# UNITED STATES PATENT AND TRADEMARK OFFICE

APPLICATION NO.	FILING DATE	FIRST NAMED INVENTOR	ATTORNEY DOCKET NO.	CONFIRMATION NO.
10/787,438	02/27/2004	Tetsunori Kaji	648.42456VX2	4727

## Office Action Summary

### **DETAILED ACTION**

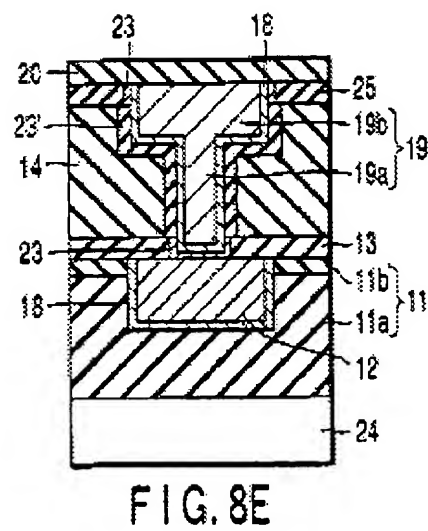
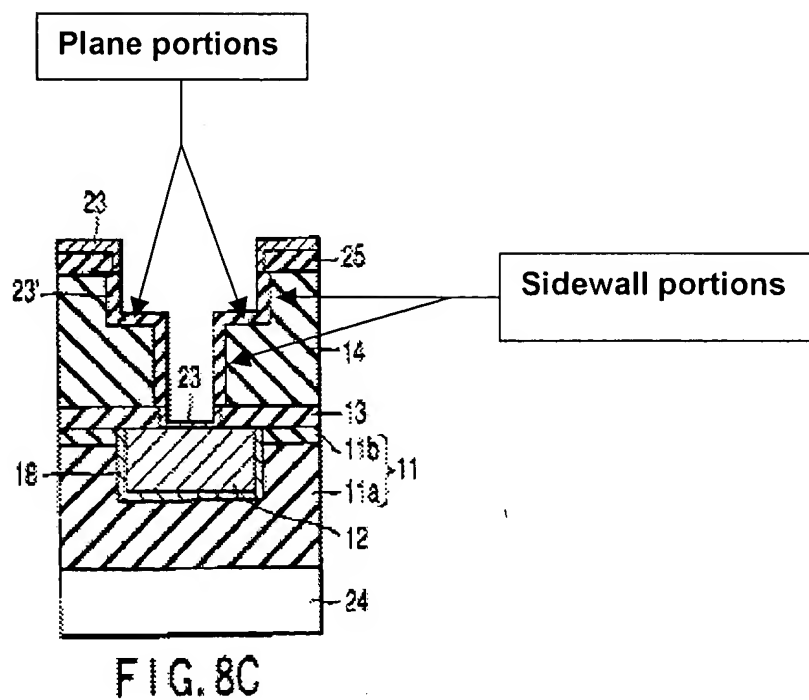
Regarding claim 1, Ito (Fig. 8E) discloses a conductive structure formed by filling copper 19 (paragraph [0060], the last 5 lines) in a plug portion 15/17 formed on an insulating film 14, the plug portion 15/17 having a metal oxide 23' (paragraph [0082]) functioning as copper barrier layer (paragraph [0084]) and formed by diffusing the metal into the insulating film 14 and reacting the metal with the insulating film 14 (paragraph [0082], lines 1-11) to reach a depth in a range of 3 nm to 50 nm (paragraph [0053] and paragraph [0077]) from the surface of side wall portions and plane portions (see Fig. 8C) defining an inner wall of the plug portion, and having copper 19 filled in the plug portion. It is noted that the conductive structure shown in Ito's Fig. 8E is a conductive damascene structure because it is formed by etching a via hole 15 and a trench 17 in an insulating layer 14 (see paragraph [0081]) (as defined by Applicant in Fig. 3 and Specification, page 19).

Regarding claim 2, Ito (Fig. 8E) discloses a conductive structure formed by filling copper 19 (paragraph [0060], the last 5 lines) in a plug portion 15/17 formed on an insulating film 14, the plug portion 15/17 having on its inner wall a two-step trench portion 15/17 comprising a large cross-section 17 and a small cross-section 15 (see Fig. 8B) via a plane portion, the plug portion 15/17 having a metal oxide 23' (paragraph [0082]) functioning as copper barrier layer (paragraph [0084]) and formed by diffusing the metal into the insulating film 14 and reacting the metal with the insulating film 14 (paragraph [0082], lines 1-11) to reach a depth in a range of 3 nm to 50 nm (paragraph [0053] and paragraph [0077]) from the surface of side wall portions and plane portions (see Fig. 8C) defining an inner wall of the plug portion, and having copper 19 filled in the plug portion. It is noted that the conductive structure shown in Ito's Fig. 8E is a conductive damascene structure because it is formed by etching a via hole 15 and a trench 17 in an insulating layer 14 (see paragraph [0081]) (as defined by Applicant in Fig. 3 and specification, page 19).

Ito (Fig. 8E) discloses a sample having a conductive structure formed thereto by filling copper 19 (paragraph [0060], the last 5 lines) in a plug portion 15/17 formed on an insulating film 14, the plug portion 15/17 having a width with a metal oxide 23' (paragraph [0082]) functioning as copper barrier layer (paragraph [0084]) and formed by diffusing the metal into the insulating film 14 and reacting the metal with the insulating film 14 (paragraph [0082], lines 1-11) to reach a depth in a range of 3 nm to 50 nm (in claim 3) or 5 nm to 30 nm (in claim 4) (paragraph [0053] and paragraph [0077]) from the surface of side wall portions and plane portions (see Fig. 8C) defining an inner wall of the plug portion, and having copper 19 filled in the plug portion provided with the barrier layer 23'. It is note that the conductive structure shown in Ito's Fig. 8E is a conductive damascene structure because it is formed by etching a via hole 15 and a trench 17 in an insulating layer 14 (see paragraph [0081]) (as defined by Applicant in Fig. 3 and specification, page 19).
